Number	Description
1	Revised Table of Contents; Added SP 907-803-2; Revised Bid Items; Revised or Added Plan Sheet Nos. 2,7, & 8001-8003; Amendment EBS Download Required.

**PROJECT: BR-0231-00(080)/104474301 - Jackson**

SPECIAL PROVISION NO. 907-803-2

SUBJECT: PDA Test Pile and Conventional Load Test

**Figure 1**

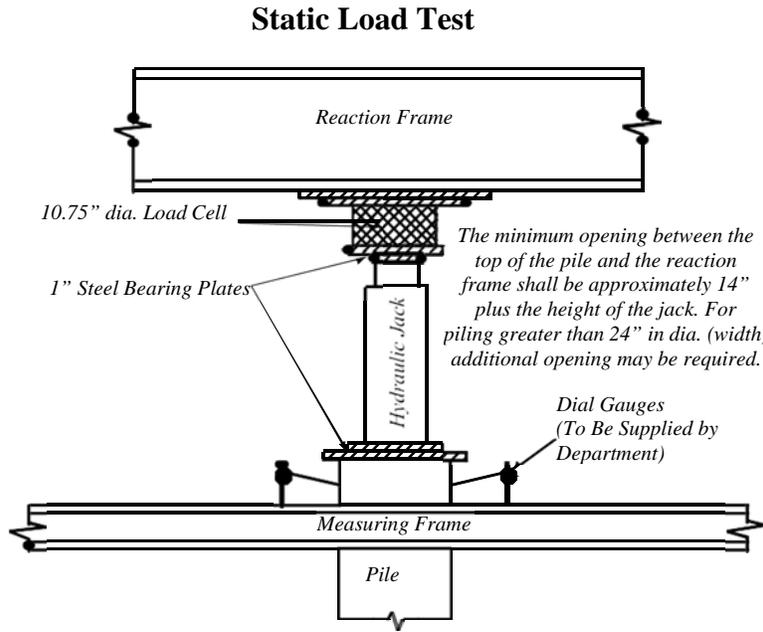
- (a) A reaction load frame capable of resisting a total load of at least 1.5 times the anticipated failure load called for herein. The frame shall consist of a beam or girder that will carry the above load while sustaining only minor deflections in the reaction system. The beam or girder shall be attached to a system of anchor piles. The anchor piles shall not be closer to the test pile than five times the diameter (width) of the pile to be tested and not less than eight feet (8-feet). See Figure 1 for additional reaction load frame requirements.

- (c) A measuring frame or a reference beam for measuring the movement of the pile during testing. Two dial gauges, supplied by the Department, will be attached to the pile as indicated on Figure 1. Each dial gauge shall be actuated by its stem or by a stem attachment resting on the measuring frame. The supports for the measuring frame shall be placed the maximum practical distance from the test pile and the anchor piles for the reaction load frame. In no case should the measuring frame be affected by movement of the test pile or the anchor piles.
